IN THE MATTER of Proposed Plan Change 18 to the
Operative Central Otago District Plan

**STATEMENT OF EVIDENCE OF ANDREW DAVID CARR
FOR CERISE ORCHARD LIMITED**

Dated 23 June 2023

Figure 1: Aerial Photograph of SH6 / Cemetery Road Intersection

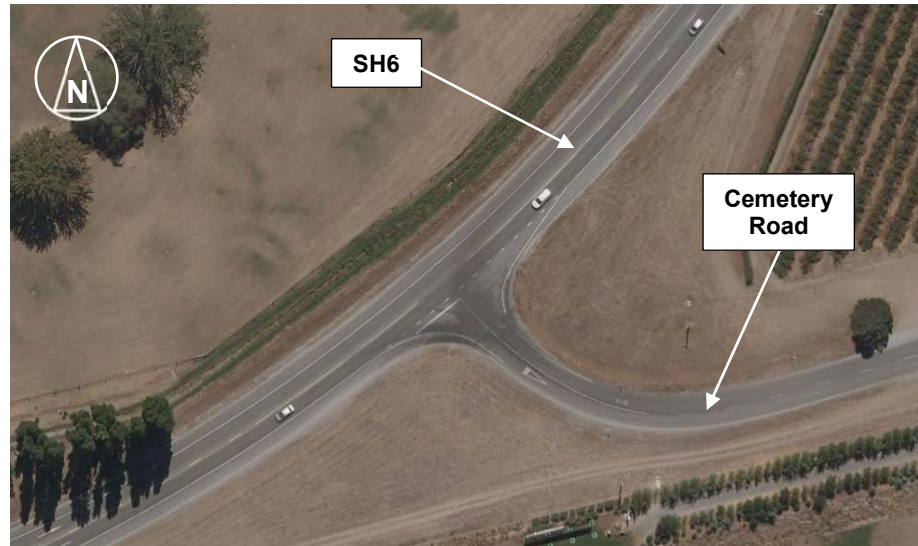
16. The SH6 / Cemetery Road intersection is presently constructed as a priority ('give-way') intersection. In this location, the state highway turns through 55 degrees via a large radius curve (in the order of 350m), to transition from an east-west alignment to the west of the intersection, to a northeast-southwest alignment to the east of the intersection.

Figure 4: Widened Shoulders at Intersection

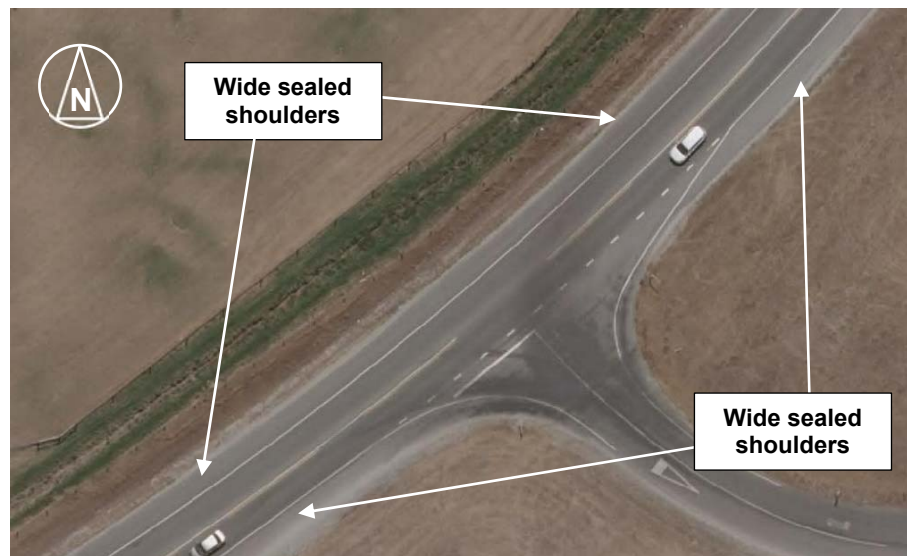
23. In other words, while the sightlines at the expected measurement point are constrained, there is ample ability immediately prior to this for drivers approaching the intersection to look to see if any other vehicles are approaching the intersection. In my view then, the sightlines are appropriate.
24. At a higher-level, the intersection is constructed as a 'Diagram E' type of arrangement. This layout has widened shoulders on all approaches and departures, and so although there are no auxiliary turning lanes as such, the areas of widened seal mean that one vehicle can pass another that is turning. For instance, if a vehicle is turning right onto Cemetery Road, another vehicle that is travelling northeast on the highway can move onto the widened shoulder to pass.

45. In my view, a right-turn bay would be straightforward to implement at this intersection. There is a distance of at least 9m available between the edge of the northbound traffic lane of the highway and the legal road boundary, which is ample to accommodate such a turning bay (which would be no more than 3.5m wide) and in practice it may be possible to simply repurpose the existing widened shoulder.
